**Joint Review Panel Request for Additional Information
Response Package
Addendum 10**

**Package 3: Geotechnical and Dam Safety, Land Use and
Land Management**

Benga Mining Limited
Grassy Mountain Coal Project

July 2019

**GEOMETRY OF NORTH ENDWALL MODEL (SECTION 1)
INCLUDING GEOLOGICAL UNITS, DAMAGE ZONE EXTENTS
AND NORTH ROCK DUMP**

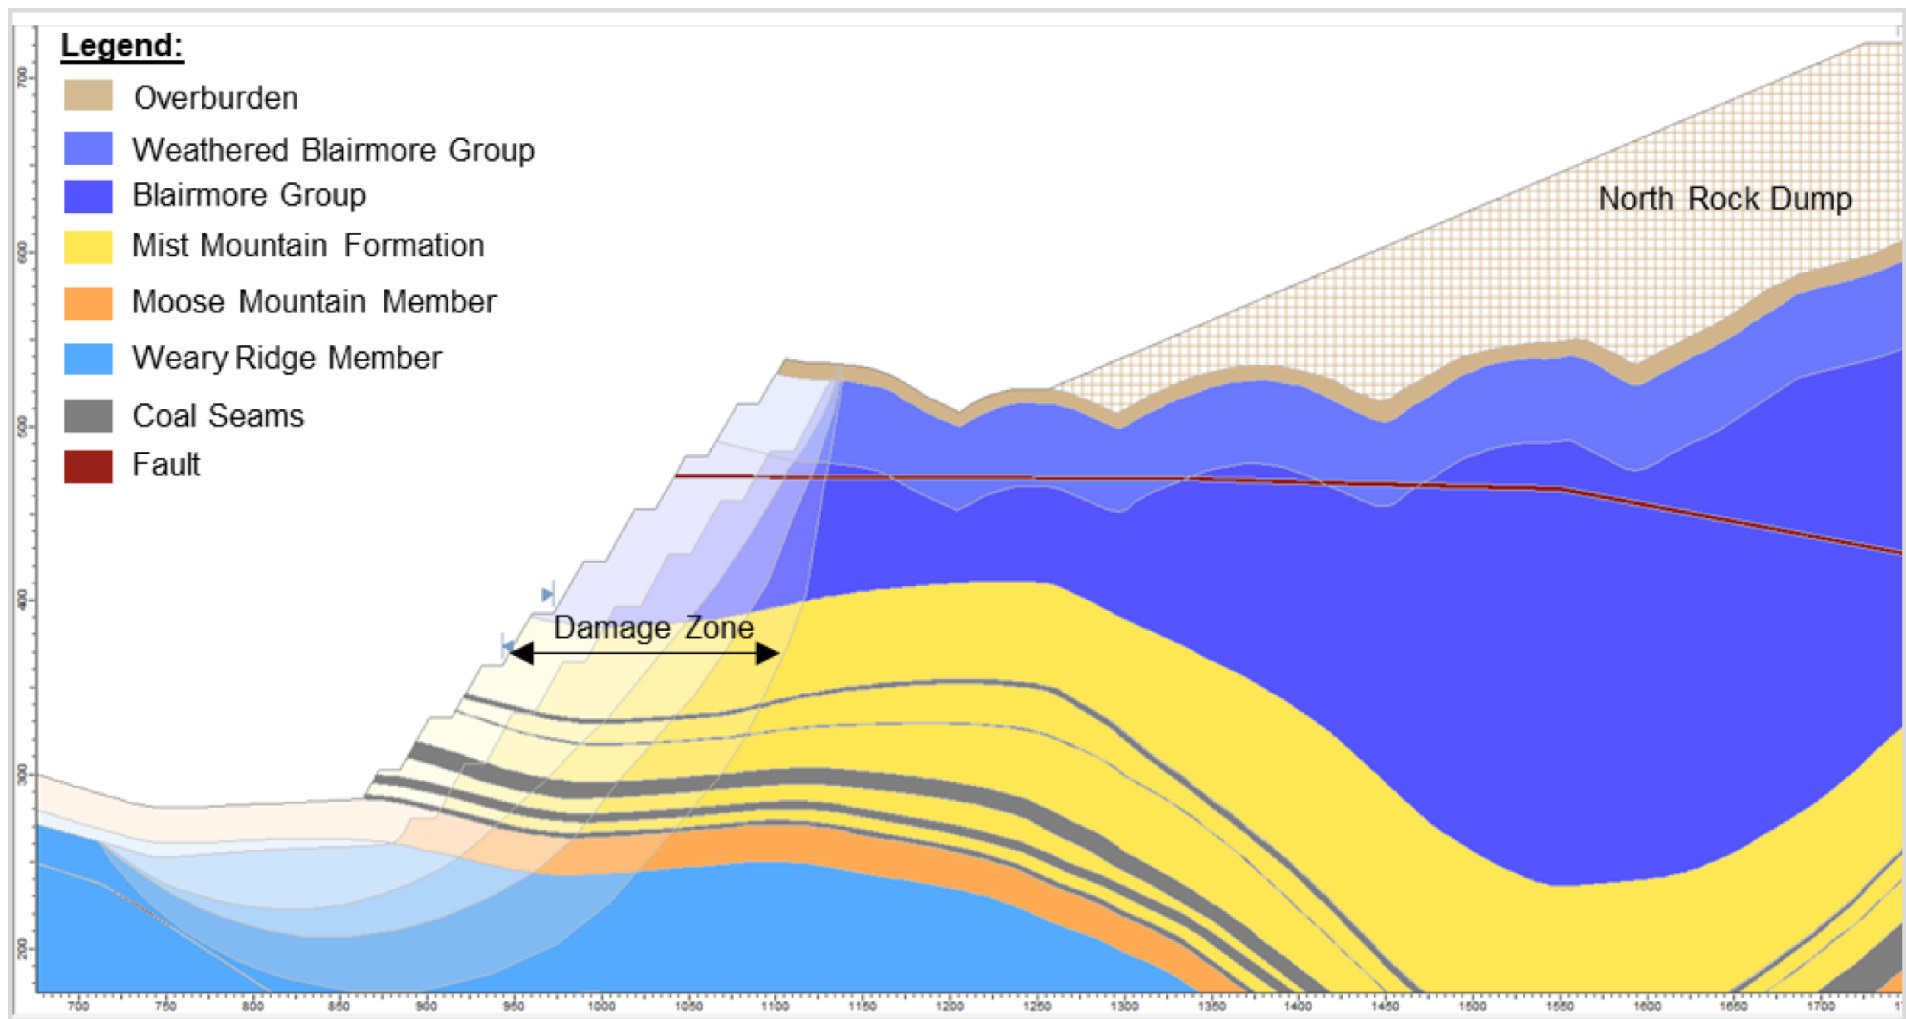
Two sections were selected to represent the rock mass and structural geology (*i.e.*, fault) conditions through the North Endwall and North Highwall (Figure 3.1-1). These sections were also selected to represent the highest slopes and where the toe of the proposed waste rock dump is located close to each pit wall. The geology associated with the endwall and highwall section are shown in Figure 3.1-2 and Figure 3.1-3, respectively.

FIGURE
3.1-4

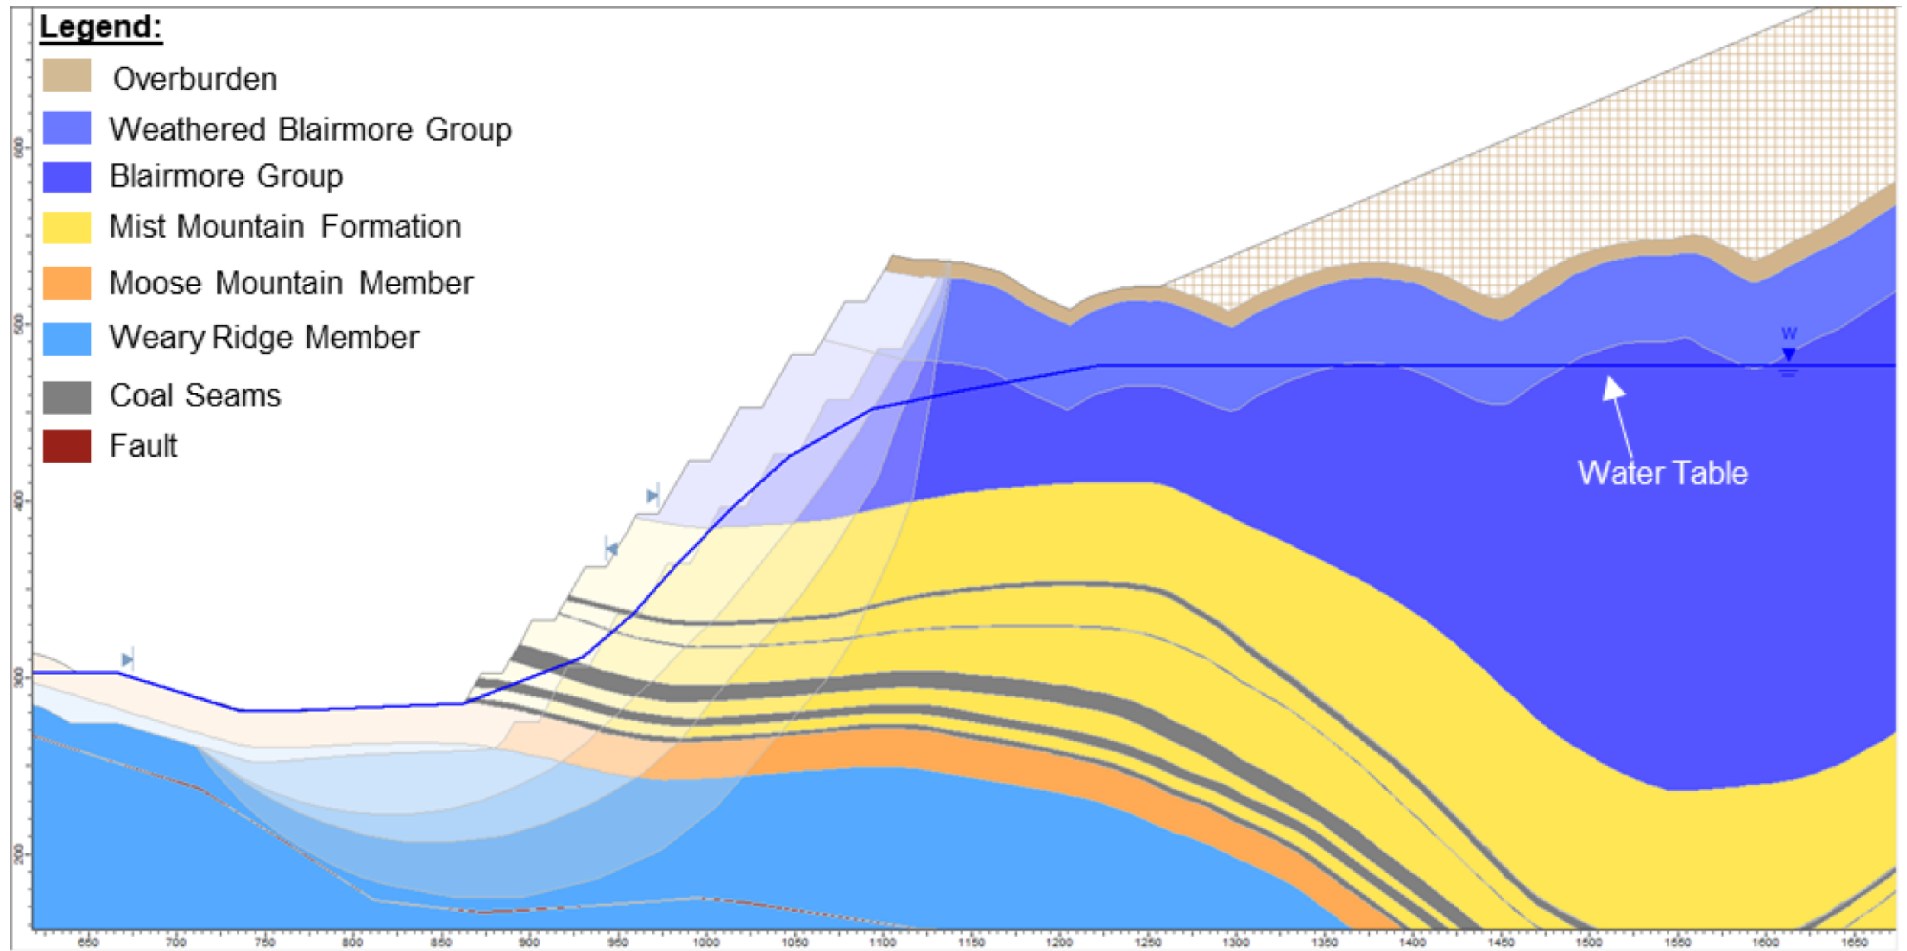
- Phreatic surface approach that utilizes a water elevation from nearby vibrating wire piezometer (VWP) monitoring, and a drawdown that coincides with the blast-induced fracture zone located 30 m behind the slope face (Figure 3.1-4).

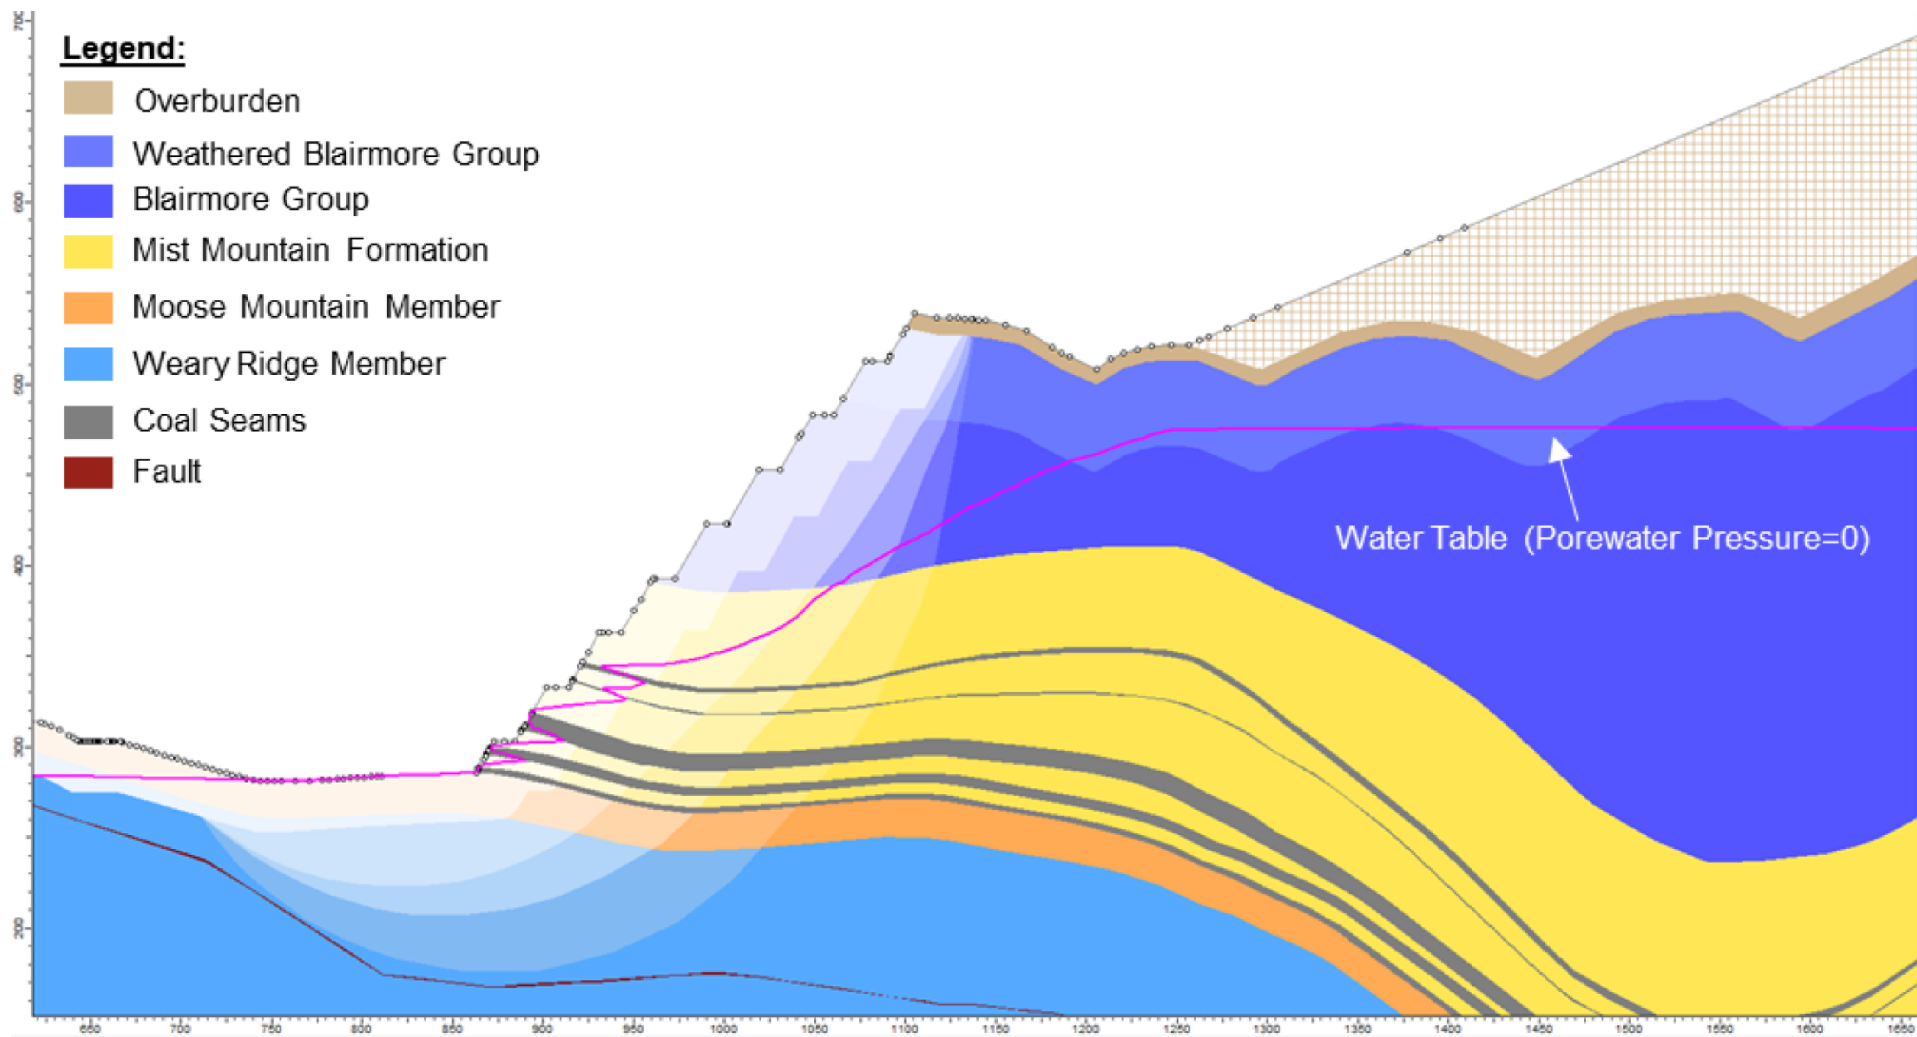
- Steady-state pore water pressure model (PPM) approach that represents the infiltration, conductivity and predicted groundwater response to mining at the completion pit slope excavation (Figure 3.1-5).
- An r_u coefficient method using a value of 0.15. The r_u method is considered to be representative of the natural dewatering of the sedimentary rock slopes (SEIS, Section B, CEAR#42) and is based on the results of the 2014 hydrogeological investigations and observations in the nearby Elk Valley (EIS, Section B, CEAR#42).

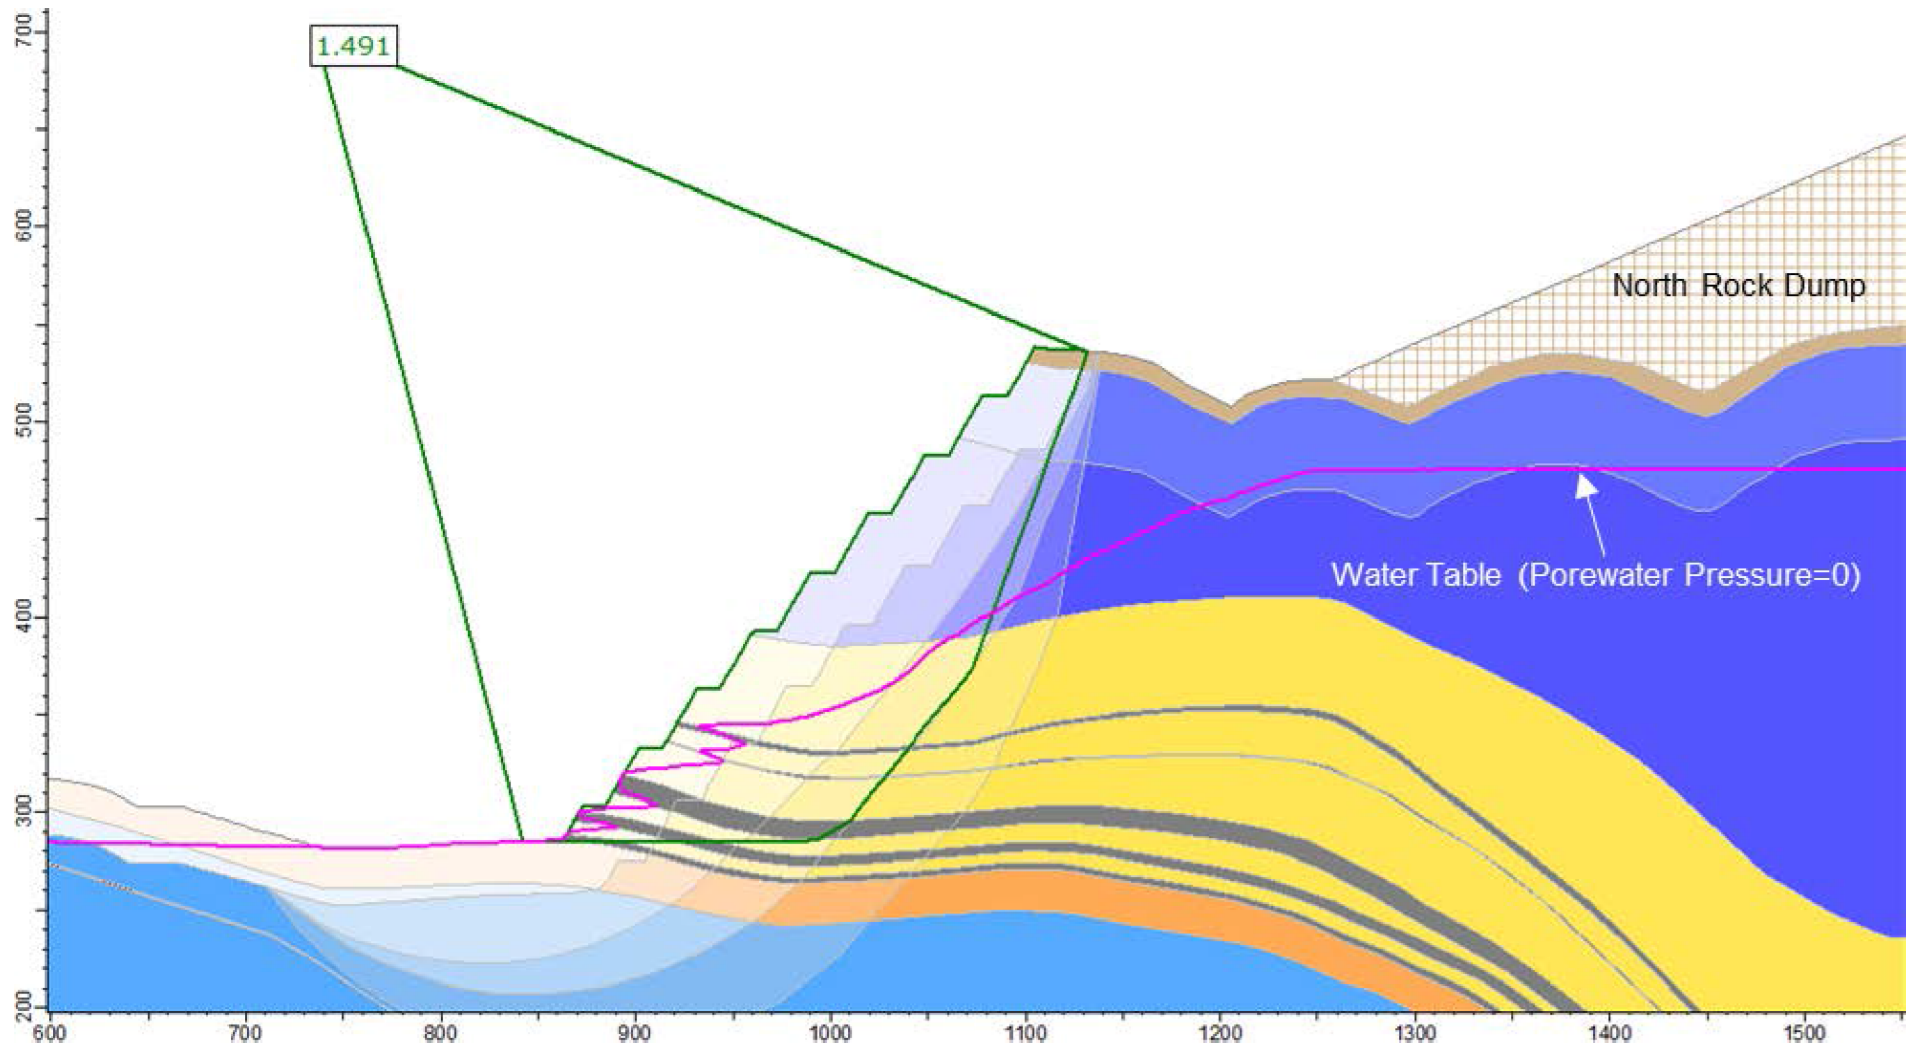
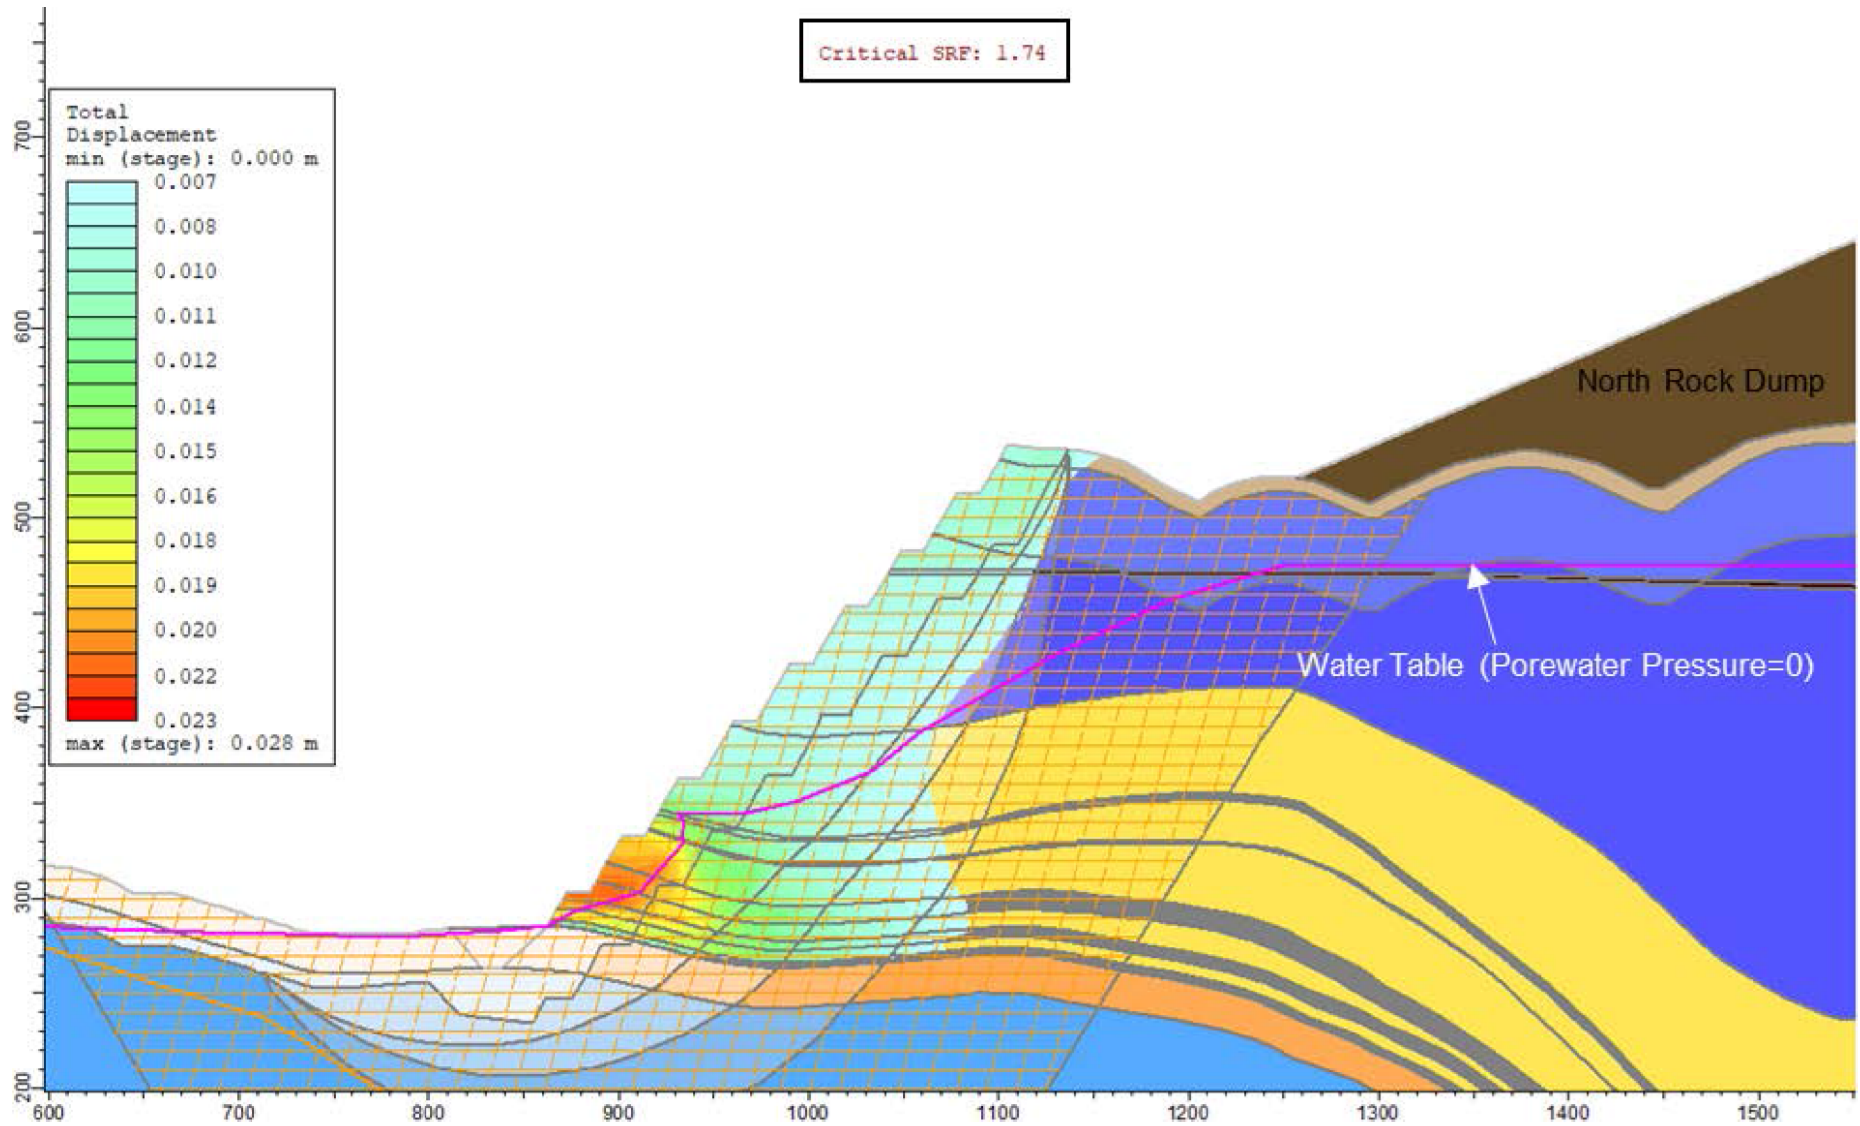
[Figure 3.1-6](#) shows the FOS (limit equilibrium) result considering groundwater conditions calculated by the PPM. The finite element model and SRF result with the same groundwater conditions is shown in [Figure 3.1-7](#).
